Access Compliance Report Public Rights-of-Way (Curb Ramps)

Main Street: ADDISON_RD Cross Street: CORONEL_RD Location: S

ADA ID: RPRK211013123356 Ramp Type: Type 6 - Directional 1 Initial Pass/Fail: Fail Overall Compliance: No Severity Score: 16

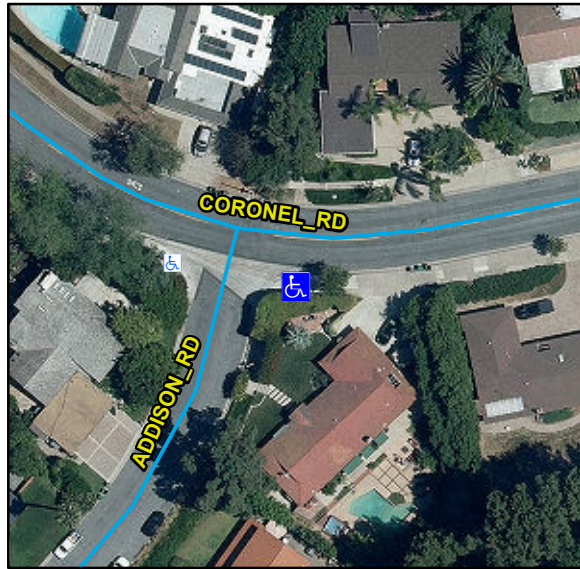
Compliance	Description	Data	Compliance	Description	Data
N/A	Ramp Length (in)	240	N/A	Flare Type LT	
Yes	Ramp Width (in)	58			N/A
Yes	Ramp Run Slope (%)	10.3	N/A	Flare Slope LT (%)	N/A
No	Ramp Cross Slope (%)	2.1	N/A	Flare Traversable LT	N/A
N/A	Grade Break	N/A	N/A	Flare Type RT	
N/A	Grade Break Slope (%)	N/A			N/A
N/A	Grade Break Cross Slope (%)	N/A	N/A	Flare Slope RT (%)	N/A
	Addl Para Ramp Left?	No	N/A	Flare Traversable RT	N/A
	Addl Para Ramp Right?	No	N/A	DWS Provided	N/A
N/A	Landing Present	N/A	N/A	DWS Contrast	N/A
N/A	Landing Length (in)	N/A	N/A	DWS Length (in)	N/A
N/A	Landing Width (in)	N/A	N/A	DWS Full Width	N/A
N/A	Landing Run Slope (%)	N/A		DWS Offset Type	N/A
N/A	Landing Cross Slope (%)	N/A	N/A	DWS Left Offset (in)	N/A
N/A	Landing Movement Obstructed?	N/A	N/A	DWS Right Offset (in)	N/A
	Landing Movement Type	N/A			
N/A	Landing Shared	N/A			
N/A	Marked Crosswalk 1	No	N/A	Clear Space	N/A
	Crossing 1 Direction	W	N/A	Clear Space To Crosswalk (in)	N/A

Marked Crosswalk 1 Width (in)	N/A			
N/A	Ramp Inside Crosswalk 1	N/A			
	Crossing 1 Slope (%)	4.9			
	Crossing 1 Cross Slope (%)	1.5			
N/A	Gutter Ponding	N/A	N/A	Curb Slope	6
Yes	Gutter Lip Height (in)	0		Road Run Slope (%)	N/A
N/A	Gutter Run Slope (%)	N/A		Road Cross Slope (%)	N/A
N/A	Gutter Cross Slope (%)	N/A		Parallel Ramp Side	N/A
Yes	Overall Surface Condition	Acceptable	Yes	Perp Joint Present	Yes
	Cross Gutter Present?	Yes		Spandrel Present?	Yes
	Replace Cross Gutter?	No		Replace Spandrel?	No

Remove & Replace Entire Ramp.

R304.5.3, STD 1115
